RE: Oldcastle Coastal Facility – 1200 NW 18<sup>th</sup> St., Pompano Beach, CPTED/Security Public Safety Plan

I have been contracted to review the drawings for security and Crime Prevention Through Environmental Design (CPTED) features in the proposed Oldcastle Bonsal Facility site plan update that is being considered for permitting by the City of Pompano Beach.

The following review is part of the required submission to have CPTED security drawing plan, and a security narrative explaining the specifications and locations of any specific security features or recommendations.

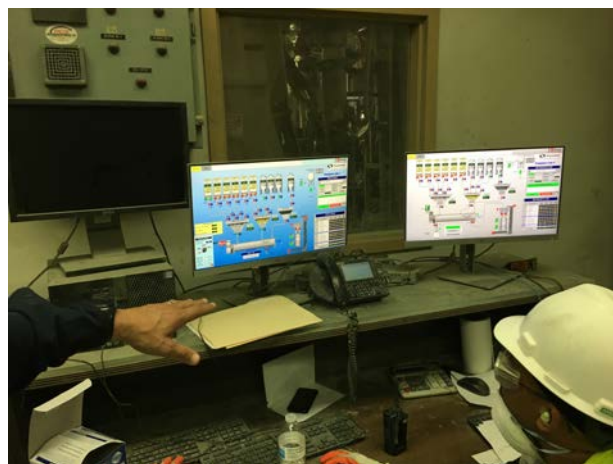
The exterior dumpster area is located in the south part of the yard area across from the Plant. The screening needs to be in working order, and lockable, and the area cleaned up. The dumpster is not set down on a concrete pad. There is no drainage capacity. The wooden gates and shielding are damaged and does not close properly. There is no locking capability to prevent outsiders from outside persons dumping trash.

There appears to be some dumping just adjacent to the dumpster. In the new site plan the dumpster will be designed to have compliant surrounding shielding and be secured.

The new proposed dumpster area should be on a concrete pad that can withstand picking up and dropping down by a garbage truck. There should be bollards/bumpers to prevent the truck from hitting the dumpster enclosure. The dumpster should be shielded on three sides with a screening that complies with zoning regulations. Swing gates that are locked should be used to protect the dumpster from illegal or unwanted dumpster diving or dumping. The front screening should be raised so that a person in the dumpster area can be observed from the outside. The gates should be lockable so they can be secured when not being used. If there is any trespassing in the exterior site areas, the person will stand out and be observed and challenged.

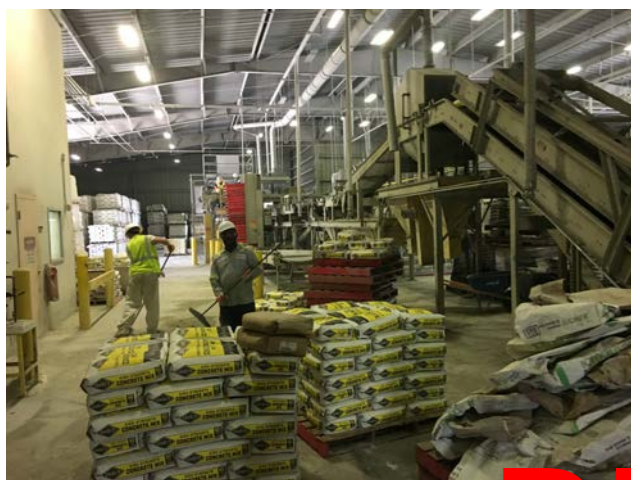
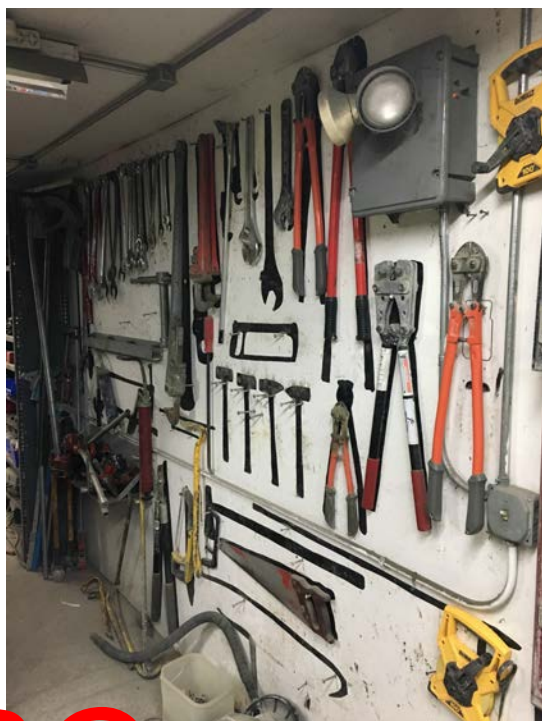
Tools and equipment is an attractive asset that need to be protected.

Forklifts and product stacked are assets that need to be protected.

Tools and machinery must be protected from loss, theft, pilferage, or vandalism.

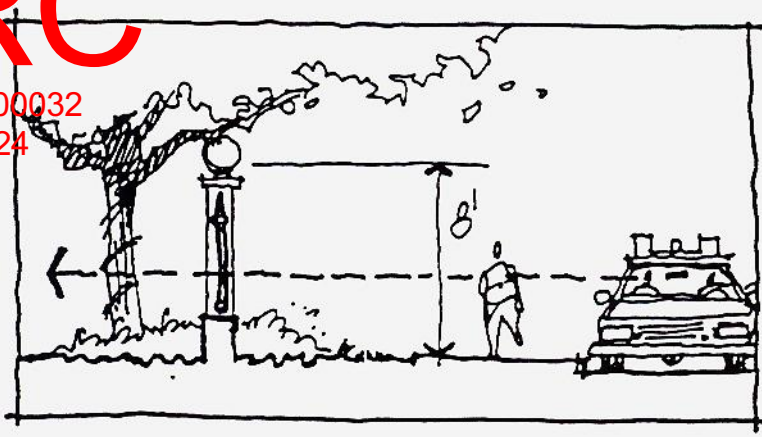
The pictures above are examples of vehicle gates and creating a secured entrance for company deliveries and vehicles.

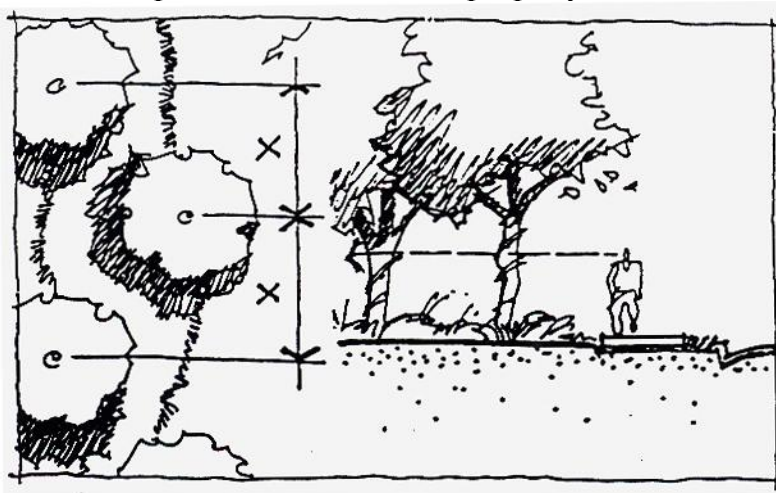
Natural surveillance – Natural surveillance is accomplished on the site by having a chain link fence on the north, south, and east boundaries. The west side boundary is being proposed to have decorative attractive code compliant decorative fencing and vehicular gates to create an entrance that allows open visibility by employees and staff and video surveillance. Police patrol will be able to readily discern any inappropriate or suspicious activity on the exterior of the fence, and see over the low shrub boundary, and under the tree canopies.

Ground plantings and hedges should be less than 3 feet and tree canopies over 8 feet to allow a clear zone of natural surveillance for police to be able to have un-obscured sight around the perimeter and into the property.
